Technical Service Pointer

Technical Service Pointer #: W11690409

Top Load Washer Wire Color Change

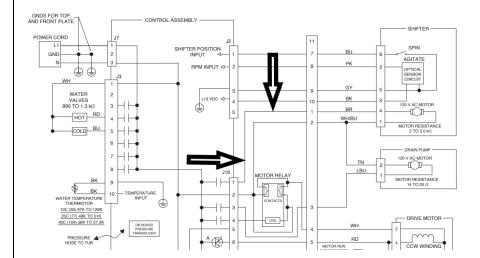
Wire color does not match schematic in upper main harness.

Due to a supply disruption there is a deviation in production to use a "Tan" color wire in place of a "Brown" wire. The wire is from Pin 1 of the J-16 connector on the CCU to the Pin 1 connection of the 12 pin Upper Main to Lower Main harness connector. See the portion of the wire diagram below with arrows pointing to the wire that is temporarily changing from Brown to Tan.
